## **ADDENDUM 03**

### **DELAWARE TECHNICAL & COMMUNITY COLLEGE ALLIED HEALTH – C-WING ADDITION & RENOVATIONS**

**Project Name:** Delaware Technical & Community  
College – Allied Health, “C” Wing  
Addition & Renovation

**Subject:** **ADDENDUM 3**

Reference: A343 Sheet: **ASK-014**

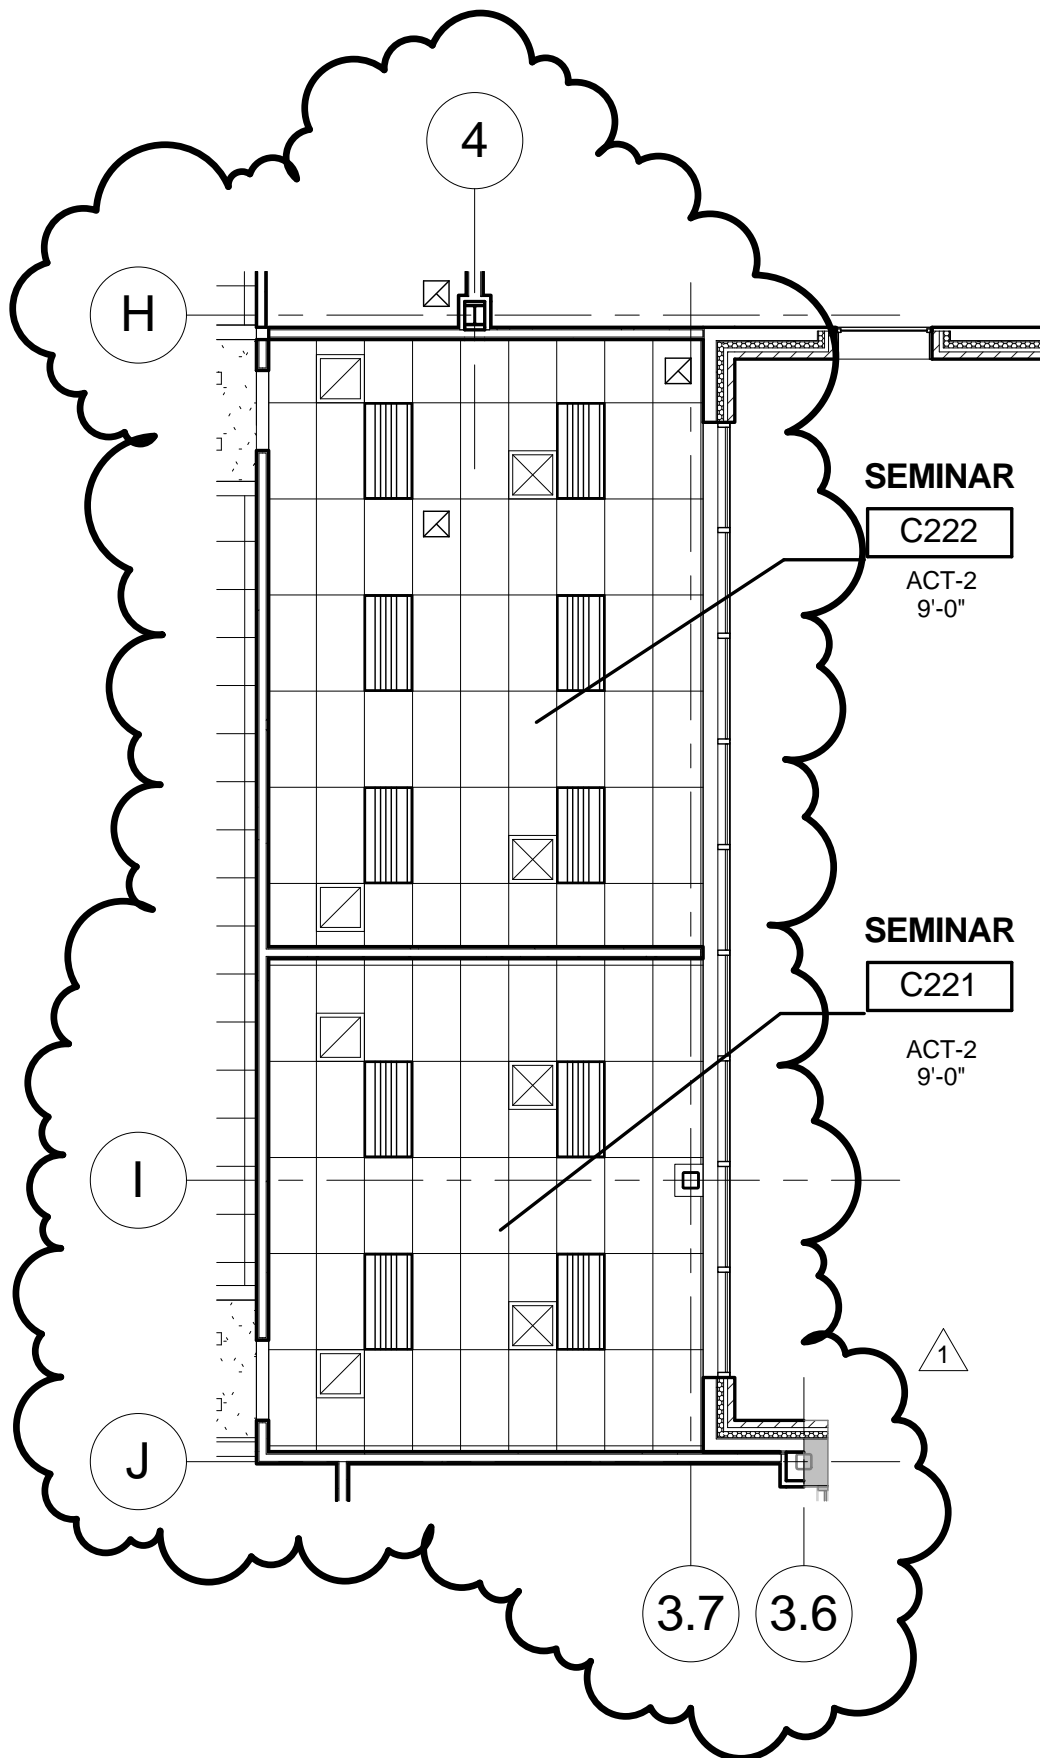
| Item No. | Description:  |
|----------|---|
| D-1      | <b>Drawing A343– Enlarged Plan Details:</b><br><br>a.) Revise door location to accommodate for standpipe. Refer to Architect’s Supplemental Sketch <b>ASK-014</b> .   |

| Reference: | A123-A3 | Sheet: | ASK-015 |

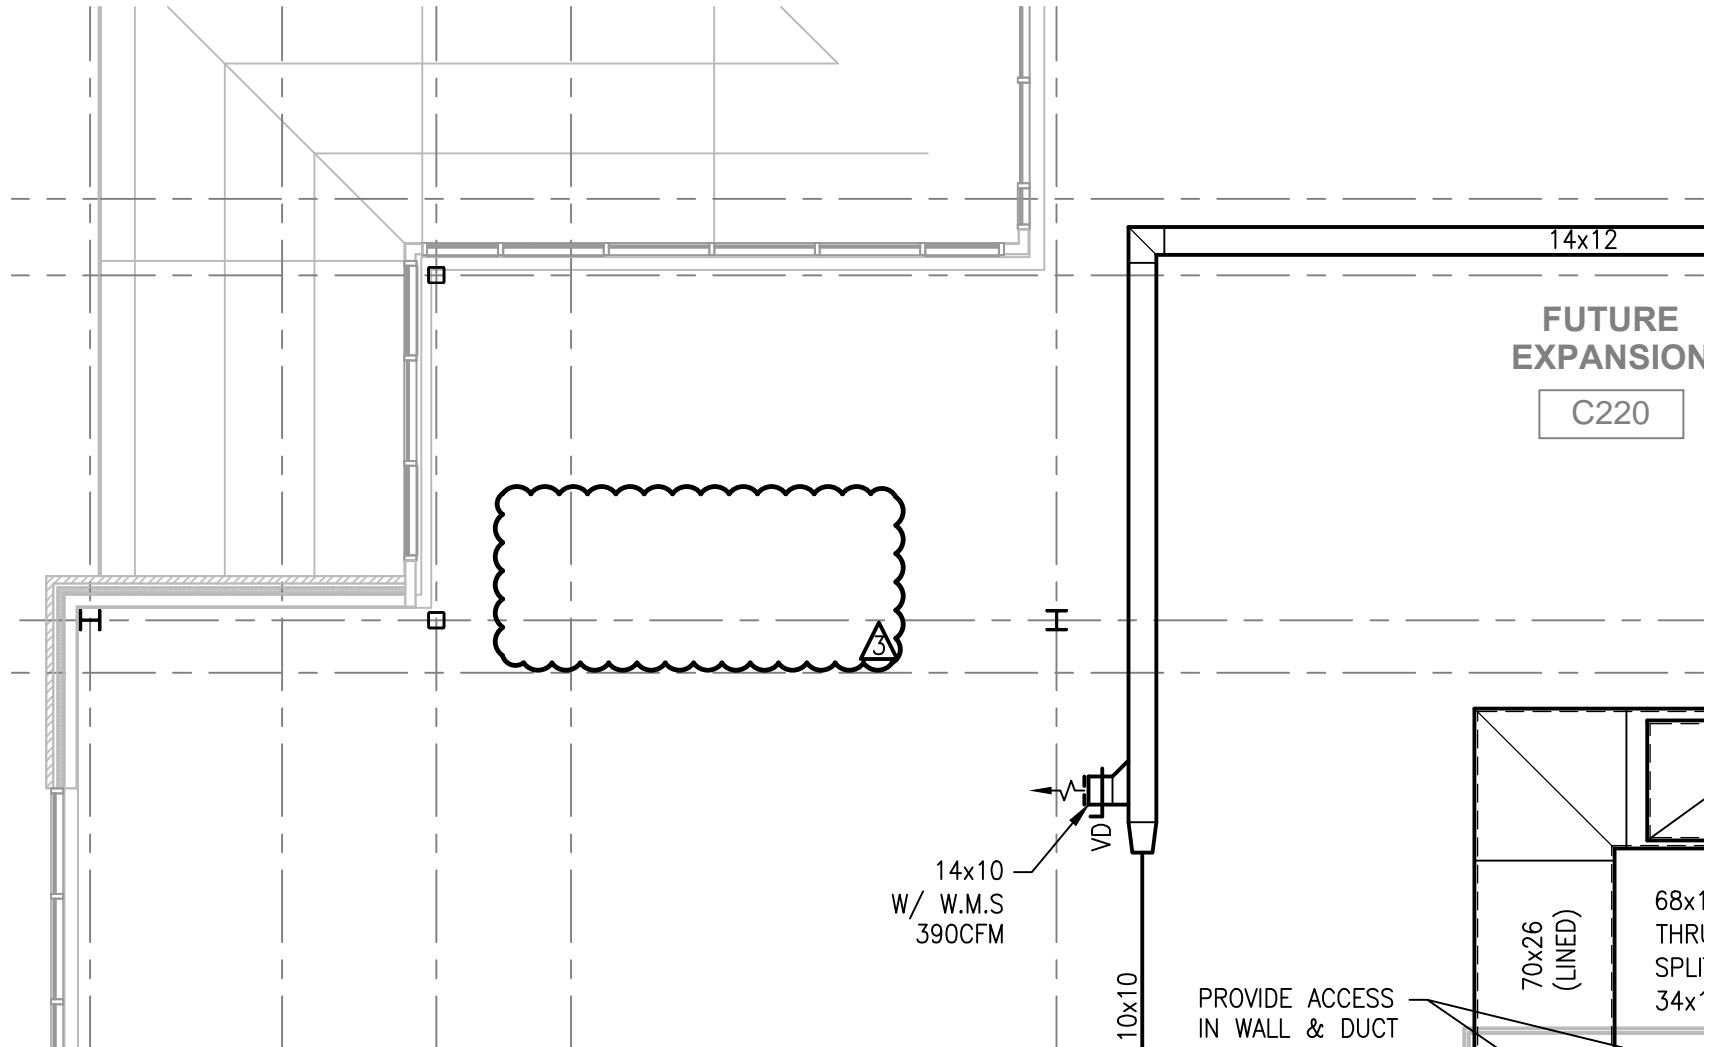
| Item No. | Description:  |
|----------|---|
| D-1      | <b>Drawing A123-A3 – Second Floor RCP – Addition – Alt. #3:</b><br><br>a.) Revise ceiling grid and lighting layout in coordination with MEP. Refer to Architect’s Supplemental Sketch <b>ASK-015</b> .  |

| Reference: | M113 | Sheet: | MSK-001 |

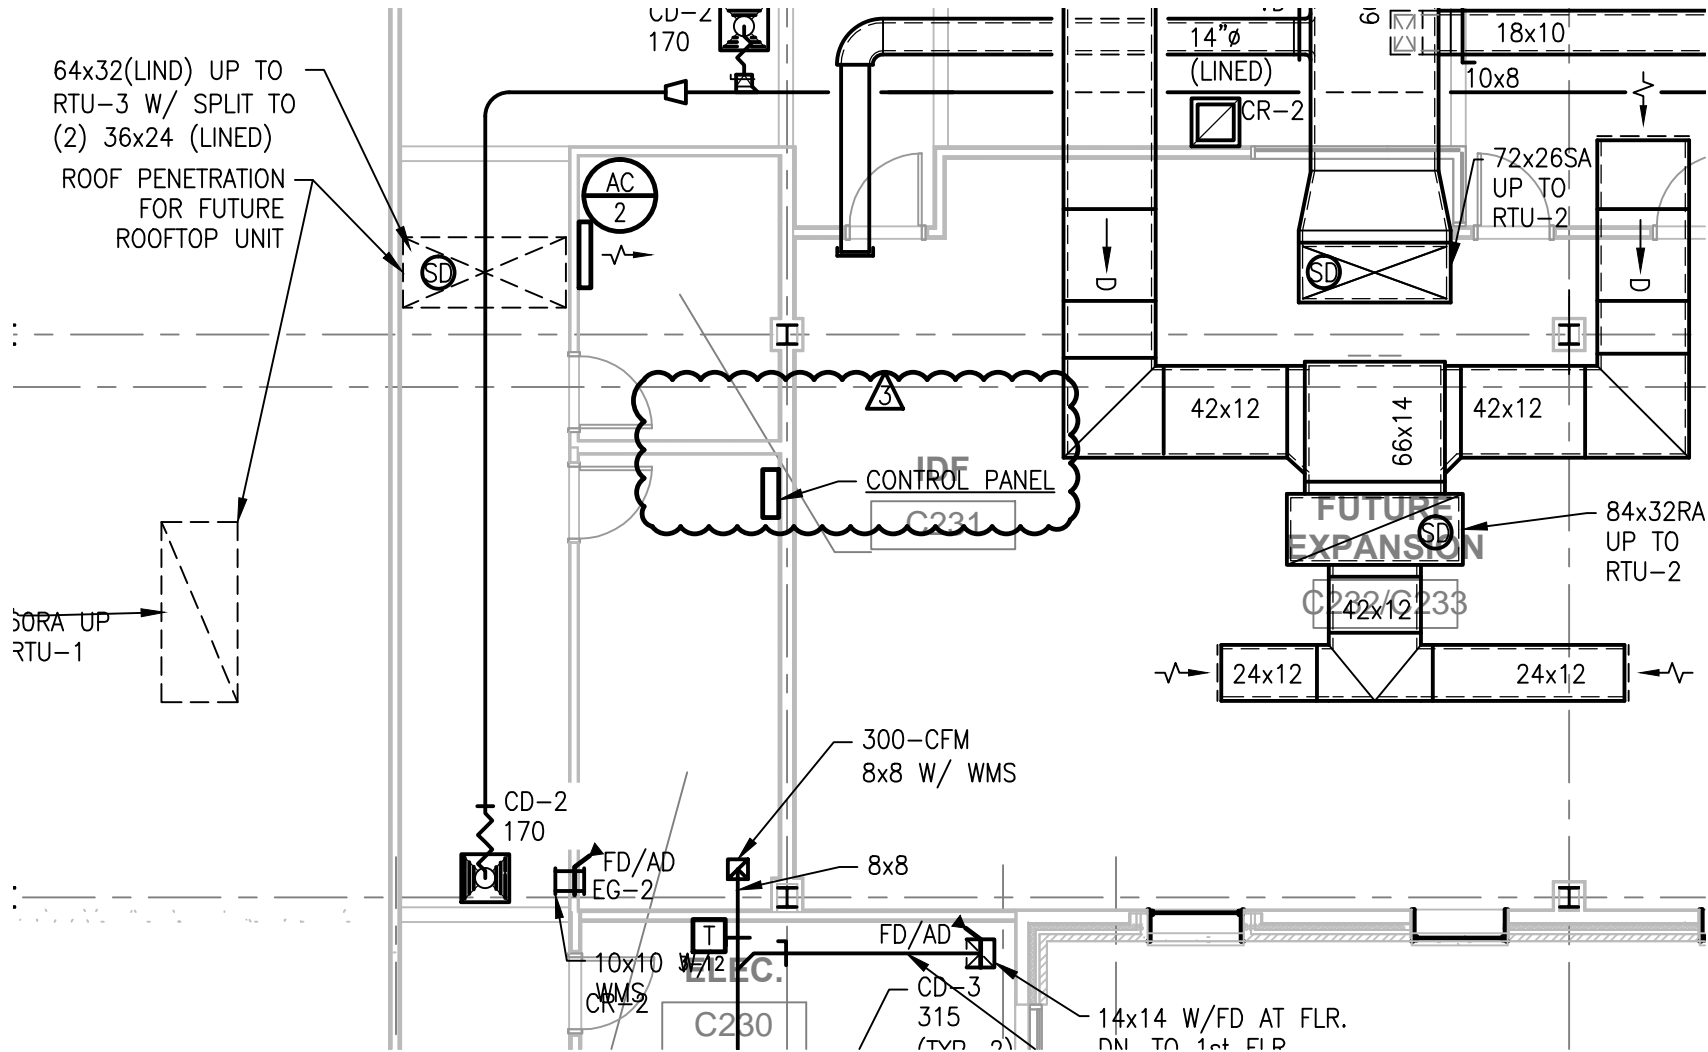
| Item No. | Description:  |
|----------|---|
| D-3      | <b>Drawing M-113 – 2<sup>nd</sup> Floor Plan - Ductwork:</b><br><br>a.) Removal of 8” duct from 1 <sup>st</sup> floor to roof. Refer to Engineer’s Supplemental Sketch <b>MSK-001</b> .<br>b.) Relocation of Control Panel from IDF room C231 to Electrical Room C230. Refer to Engineer’s Supplemental Sketch <b>MSK-002</b> . |

| Reference: <b>M102</b>  | Sheet: <b>MSK-003</b> |

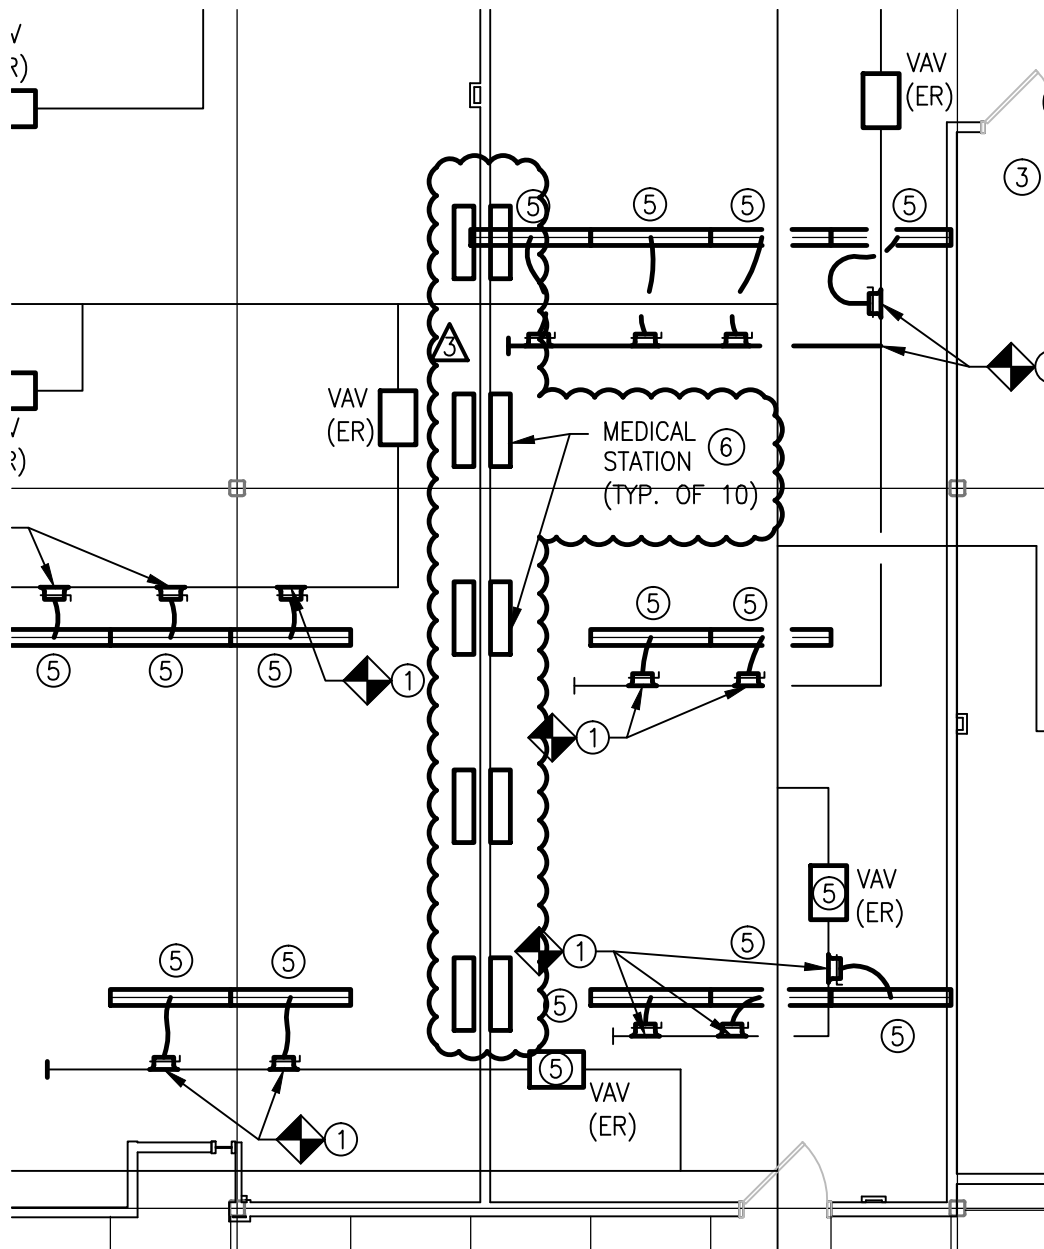
| Item No. | Description:  |
|----------|---|
| D-5      | <b>Drawing M102 – 2<sup>nd</sup> Floor Plan – Mechanical Demolition:</b><br><br>a.) Removal of demolition work from Base Bid. Refer to Engineer’s Supplemental Sketch <b>MSK-003</b> .  |

| Reference: | M102-A6 | Sheet: | MSK-004 |

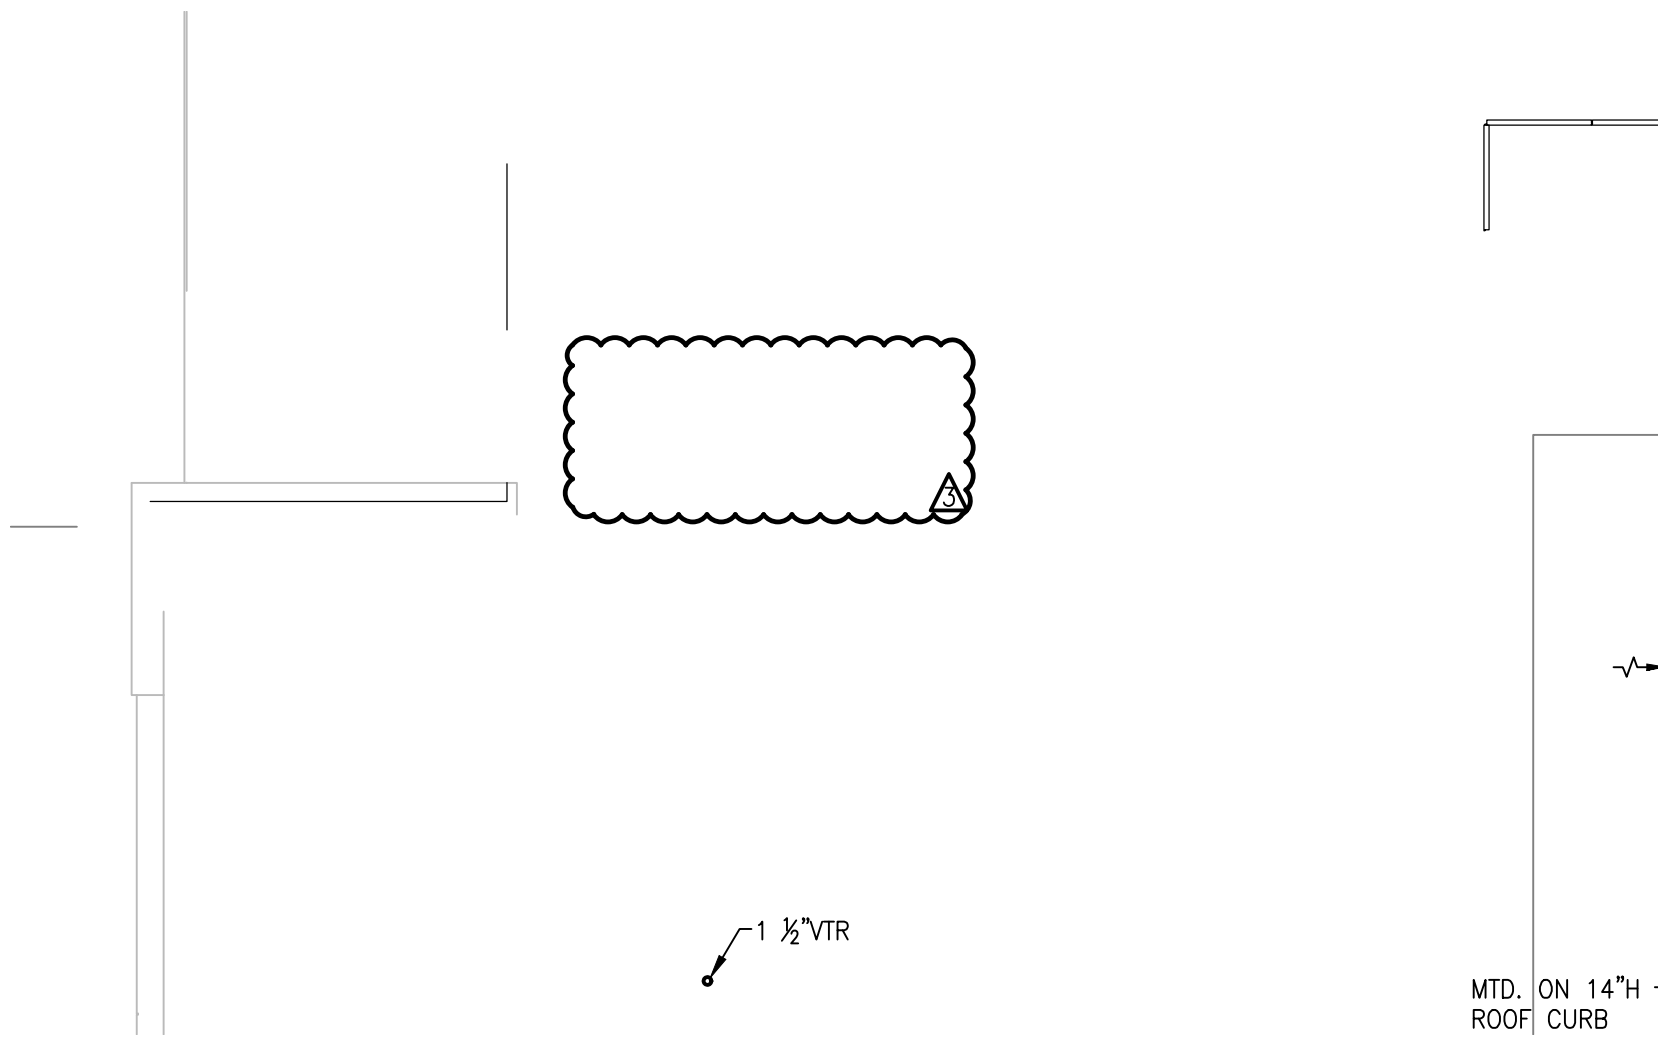
| Item No. | Description:  |
|----------|---|
| D-6      | <b>Drawing M102-A6 – 2<sup>nd</sup> Floor Plan – Mechanical Demolition:</b><br><br>a.) Add of demolition work to Alternative #6. Work removed from Base Bid. Refer to Engineer’s Supplemental Sketch <b>MSK-004</b> .   |

| Reference: | M171 | Sheet: | MSK-005 |

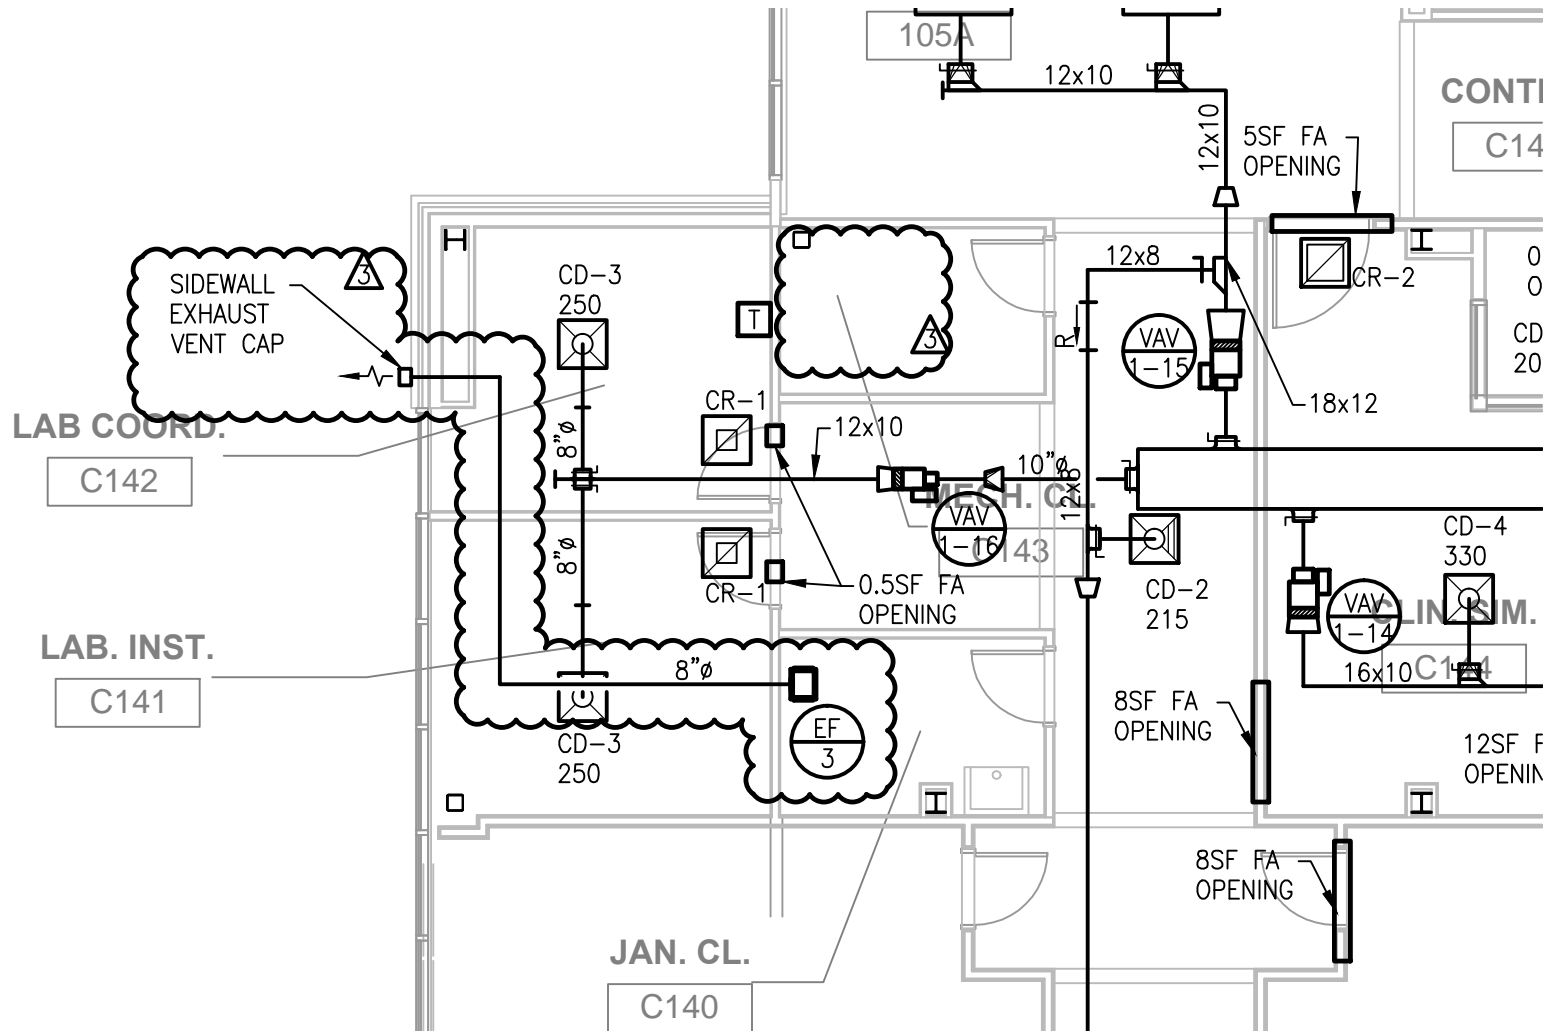
| Item No. | Description:  |
|----------|---|
| D-7      | <b>Drawing M171 – Roof Plan:</b><br><br>a.) Removal of 8” Duct Penetration and cap termination from Base Bid. Refer to Engineer’s Supplemental Sketch <b>MSK-004</b> .  |

| Reference: | M111 | Sheet: | MSK-006 |

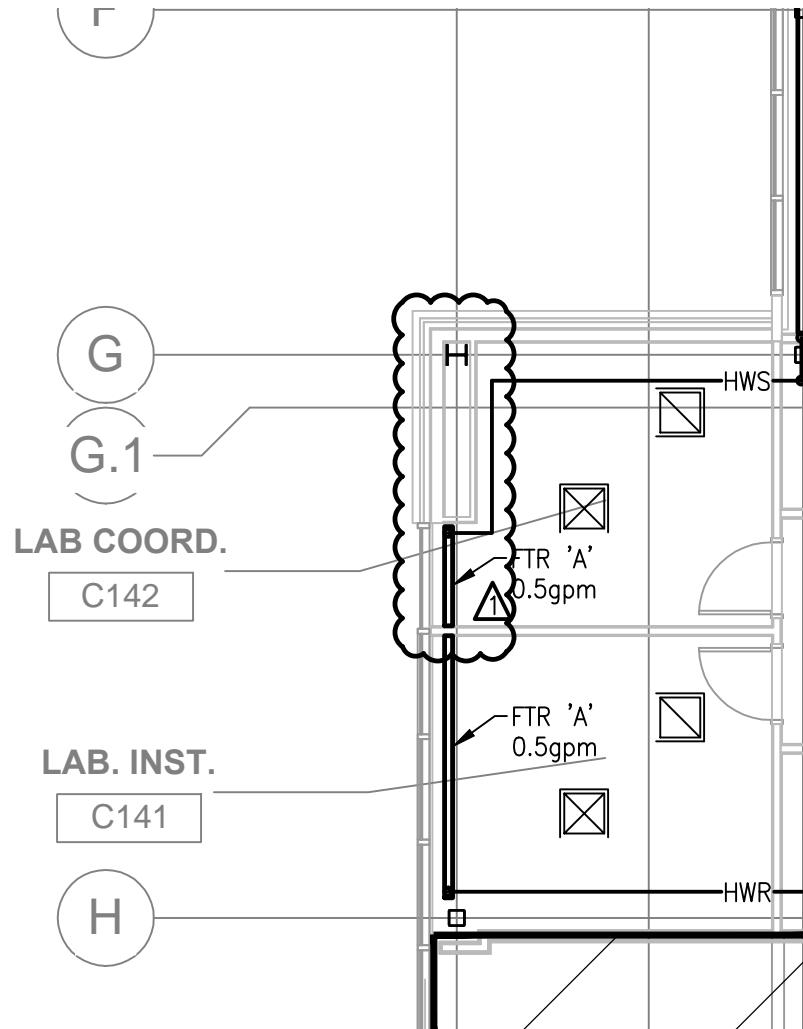
|             |  | <p>a.) Relocation of EF-3 from Water Room to Janitors Closet C140. Provide 8” ductwork above ceiling, and terminates at sidewall of Lab C142. Provide sidewall vent cap. Refer to Engineer’s Supplemental Sketch <b>MSK-006</b>.</p> |
